Public Response to the Director's Report on the Indiana 2016 IRPs

Submitted to the IURC on September 1, 2017

**on behalf of CAC, Earthjustice, Indiana Distributed Energy Alliance,
Sierra Club, and Valley Watch**

Figure 3. Vectren’s Process Flow Chart for Strategist Modeling

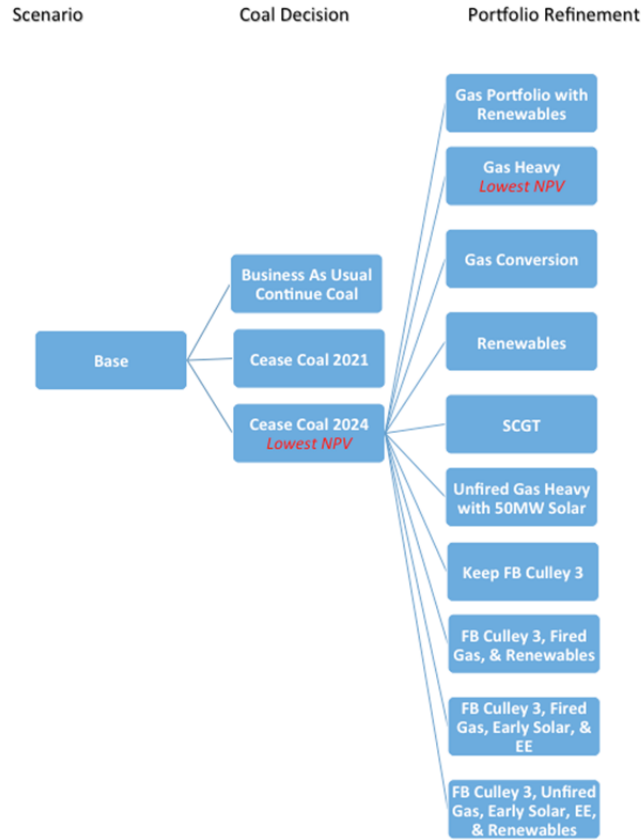
First, Vectren’s Process Flow Chart leaves out a fourth step, which is the construction of the final portfolio in each scenario. The third step shown in Figure 3 above (Vectren’s so-called “Portfolio Refinements”, a term that is literally never used in Vectren’s IRP) does not result in a final version of each scenario. Vectren’s flow chart does nothing to rectify our concern: the relationship between the eight modeling runs performed for each scenario and the final scenario run is completely undescribed.

In addition, each of the portfolio refinements is characterized in large part by requiring the model to include specific generation units—a modeling procedure that is at odds with any optimization process. Indeed, to call any of the scenarios run by Vectren “optimized” is, at best, disingenuous.

Finally, Vectren’s process flow chart sheds no light on the development of the “Balanced Energy” portfolios.
